March 27, 2015

**Subject: Century Tire Plaza – 195 Kennebec Street
Project ID# 2015-027
Review Comments Received March 24, 2015**

BUILDING A PLAN

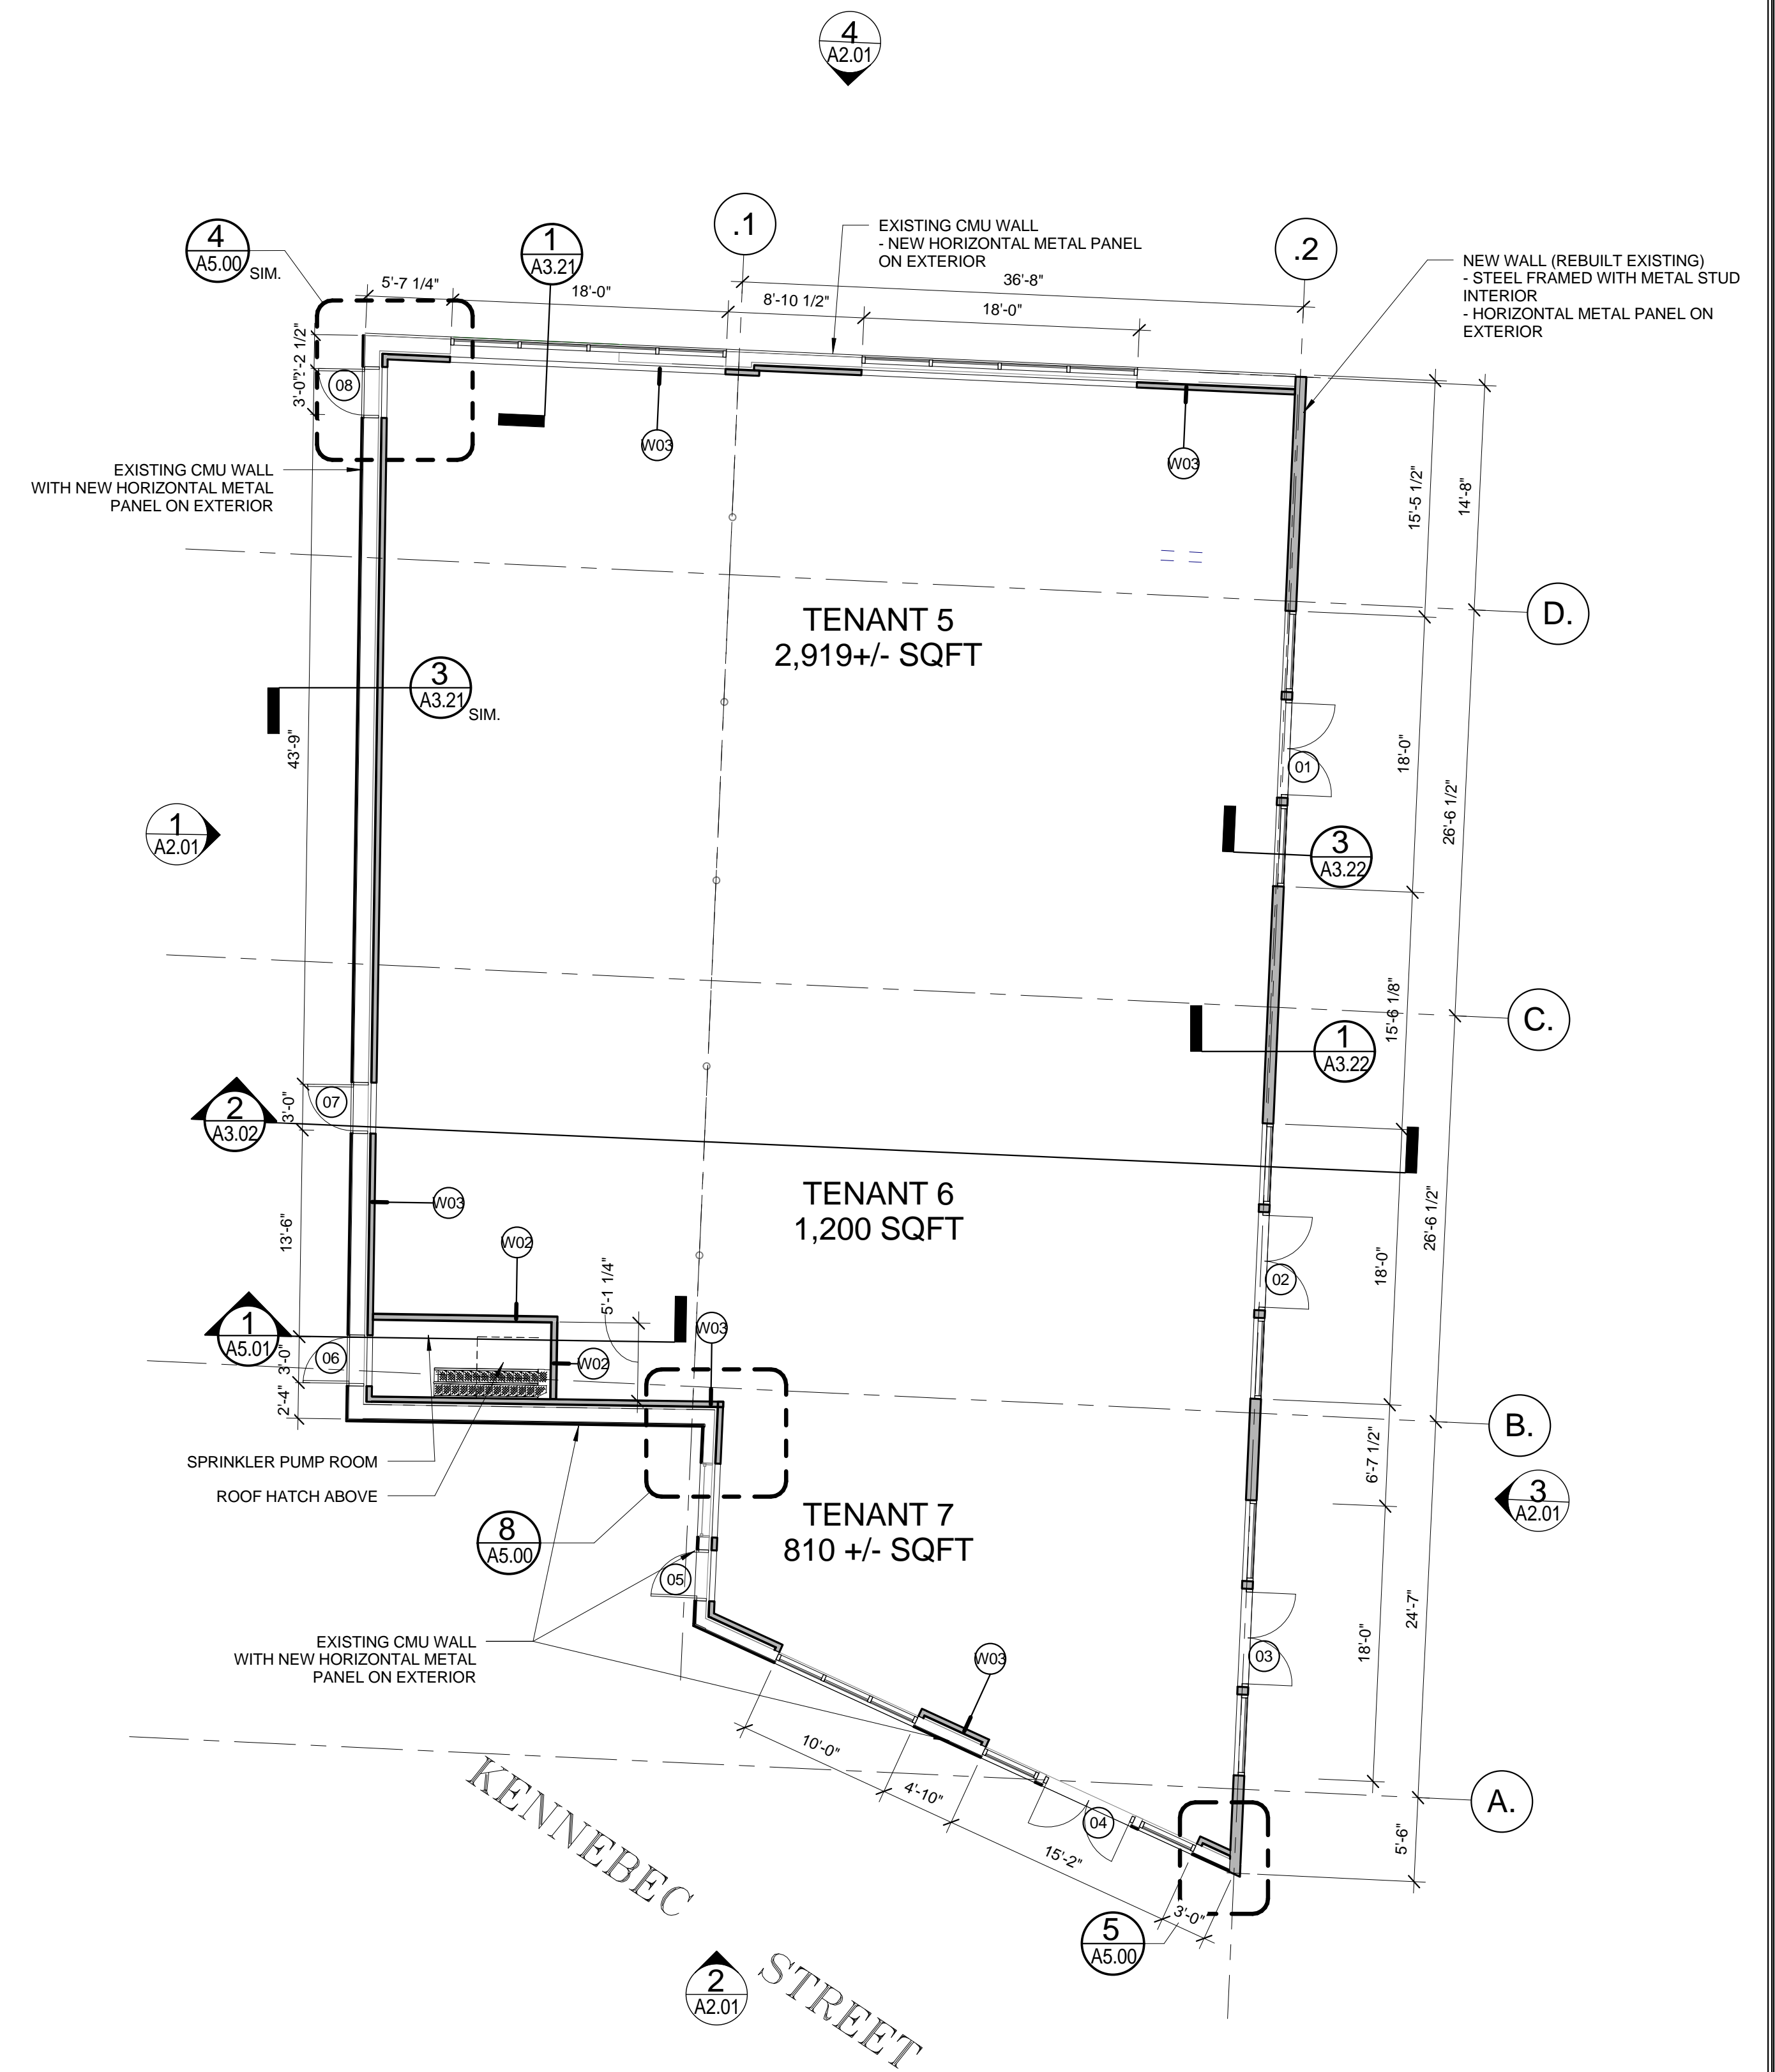
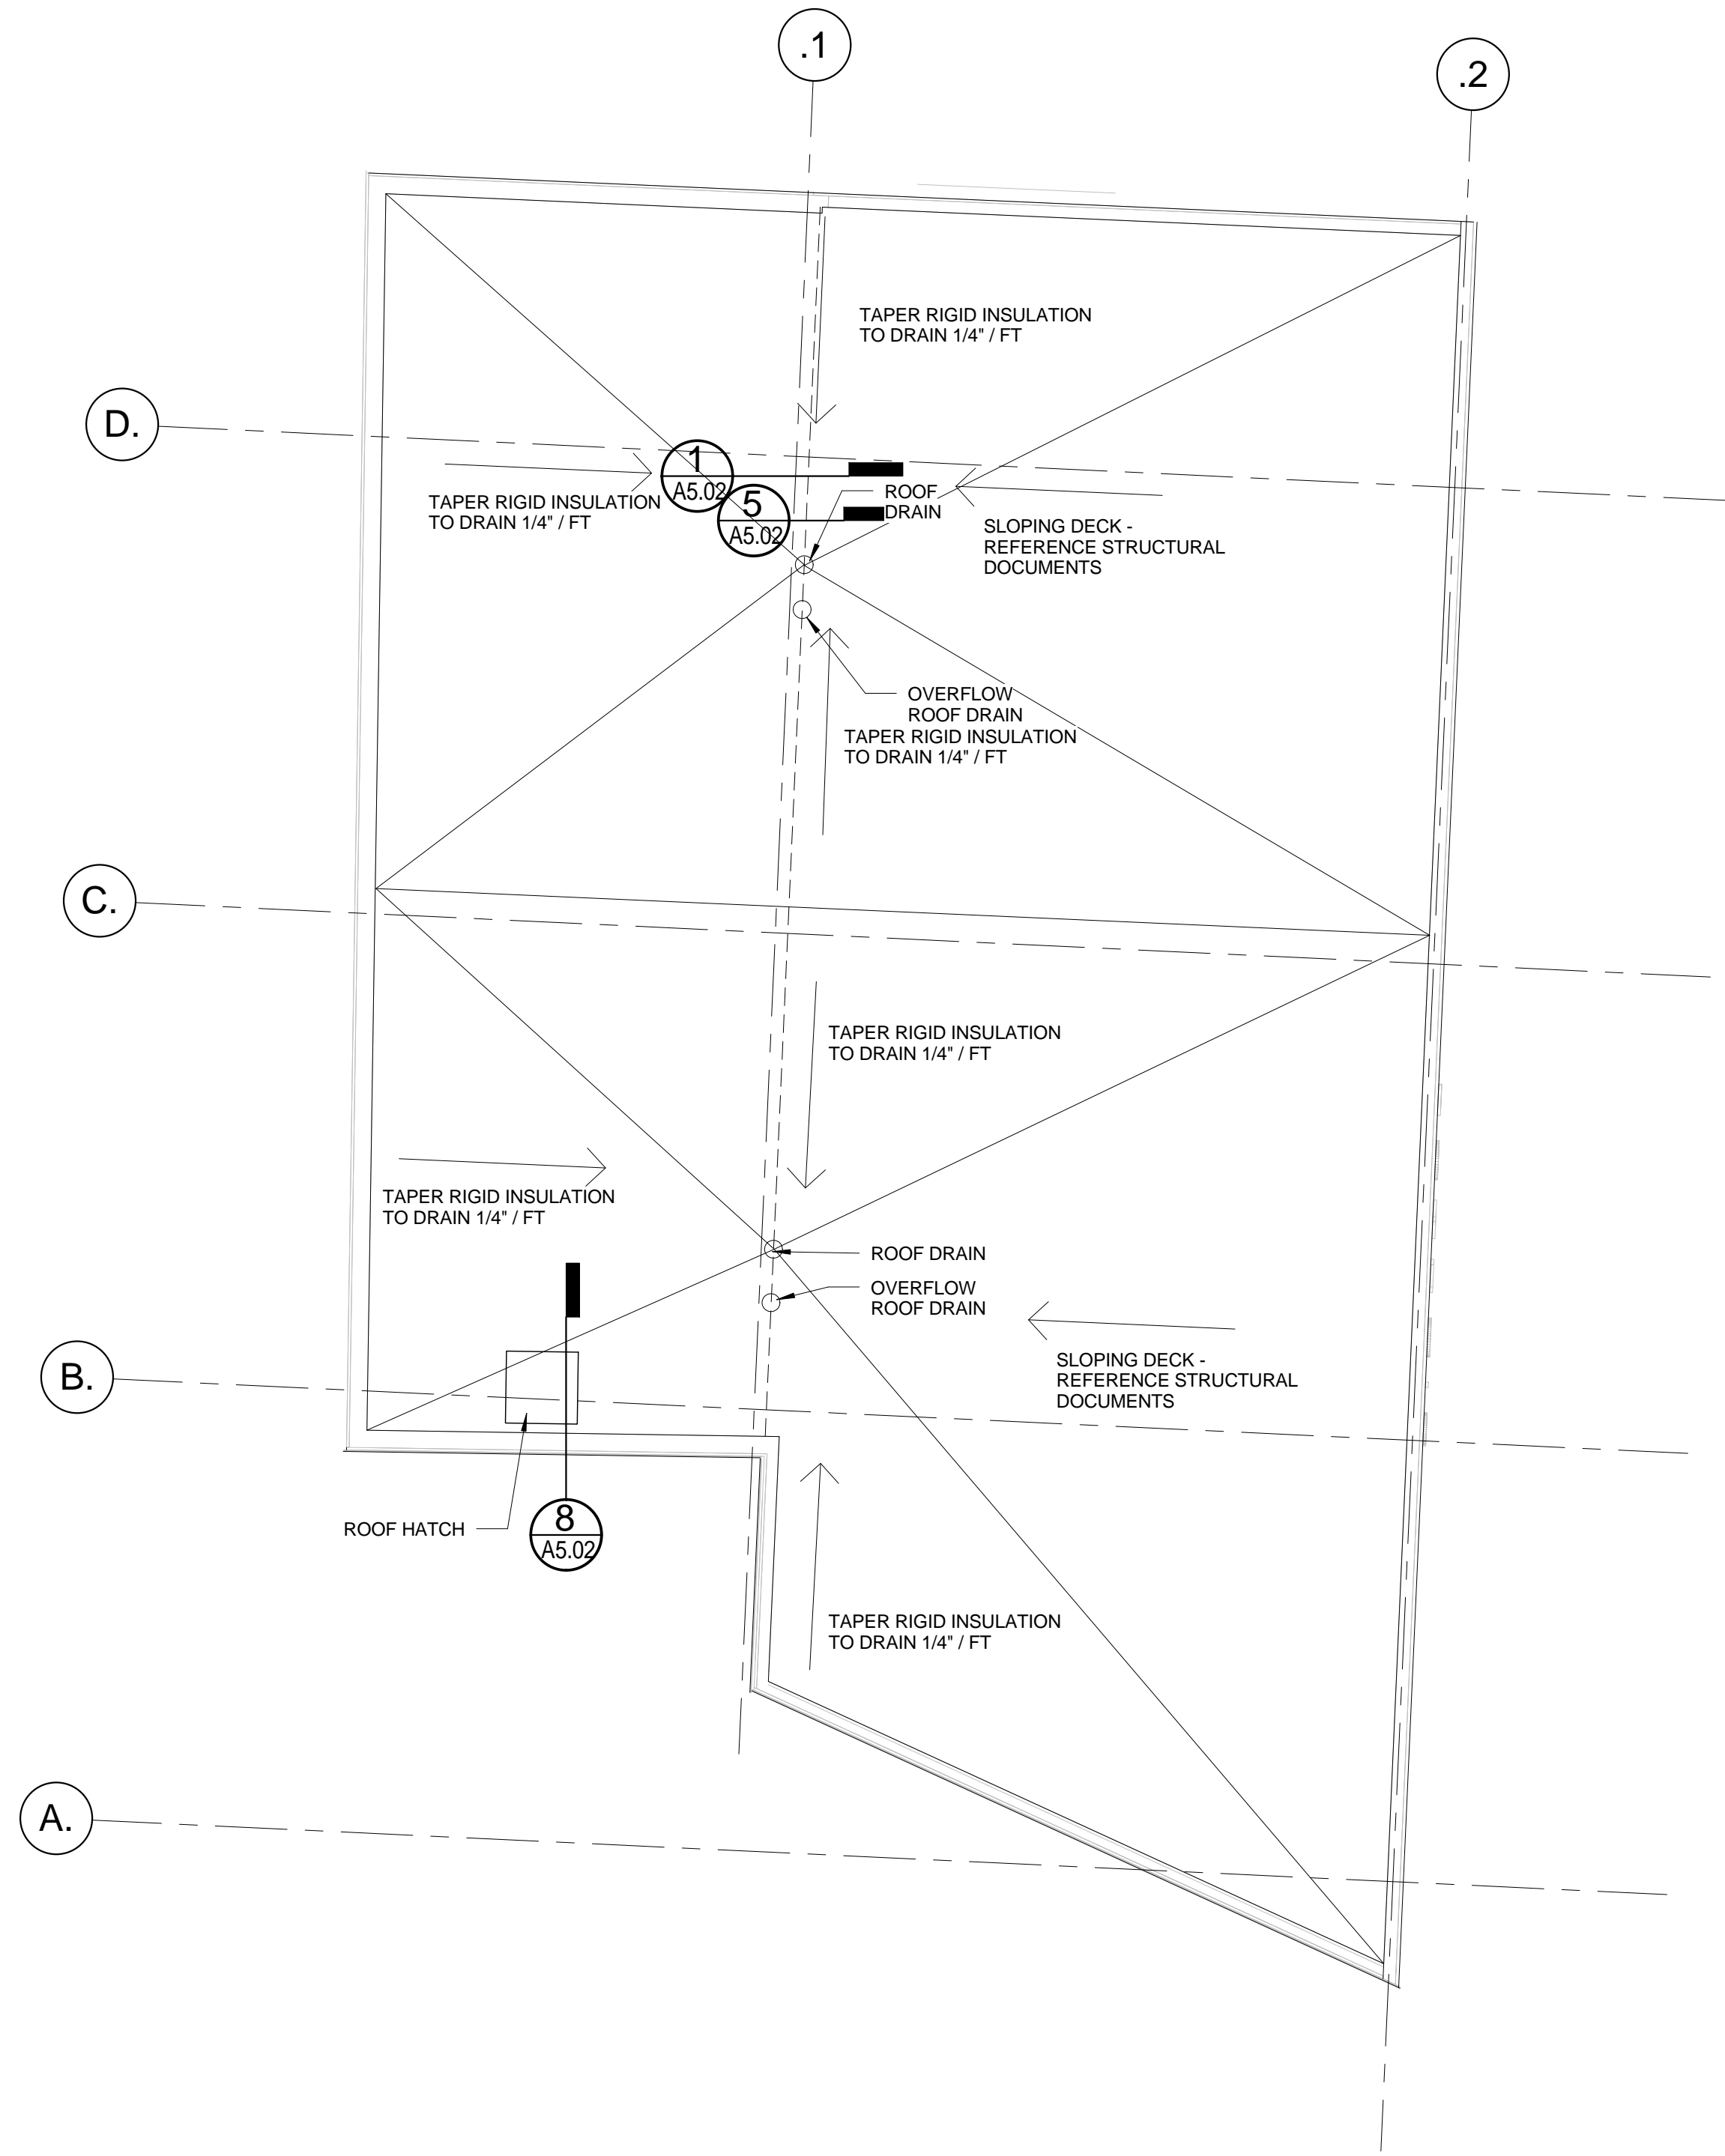
Under Section 14-299(0), the B-7 zone requires that “[a]ll buildings shall have a minimum of one (1) public pedestrian entrance facing the street frontage of the lot.” Given this standard, plans should be revised to show Building A with an entrance on Kennebec Street.

The revised Architectural plans show a doorway on the Kennebec Street side of Building A.
